Environmental Review Team
Report
on

D.B.S. Subdivision
Canterbury, Connecticut

March 1979

The Eastern Connecticut Environmental Review Team was requested to provide an environmental assessment of the proposed DBS Associates subdivision, located on the eastern side of the intersection of Kinne and Corey Roads in Canterbury. Preliminary site plans have been developed by Albert Fitzback, R.L.S. of Putnam. Engineering for septic systems will be designed by Dimmock Associates. The total parcel for subdivision is approximately 73 acres. The initial proposal which was field reviewed by the Team and is discussed in detail consists of 7 lots fronting on Kinne Road on 38± acres. An additional 35± will be subdivided into lots 8 through 11 which are discussed in general terms in this report.

ANTICIPATED PATH OF SEPTIC SYSTEM EFFLUENT

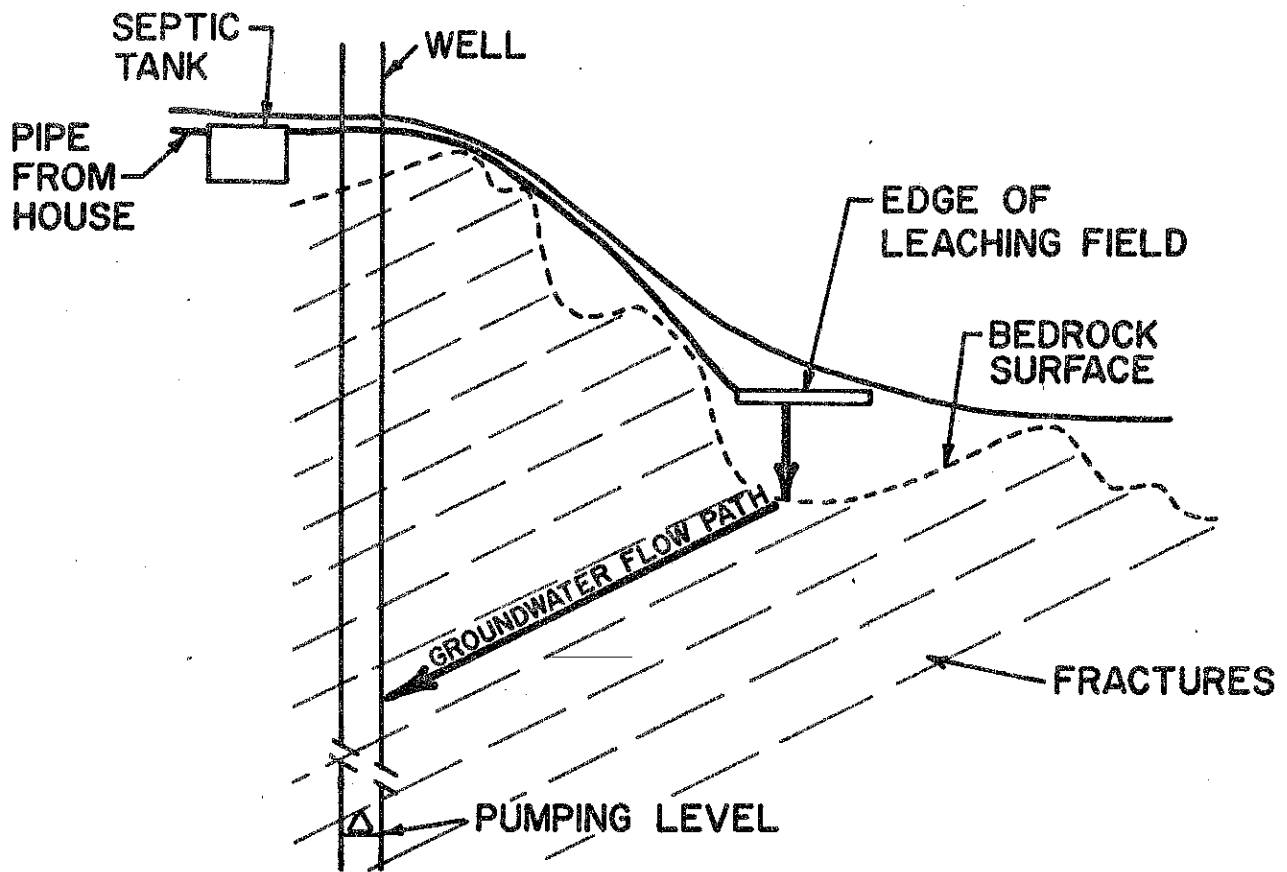
A more pressing concern is the operation of septic systems in the subdivision. Much of the property is shallow-to-bedrock, although deep pockets of till exist in several areas. Even if the wells are drilled uphill of the leaching fields, the dip of the most prominent fractures virtually assures that wastewater ultimately will be recycled to the wells. Hence, it is urgent to provide adequate filtration of the effluent in the overburden. Judicious site selection, coupled with appropriate engineering measures, is needed to assure suitable depths and areas of soil in order to avoid serious water-quality problems in the future.
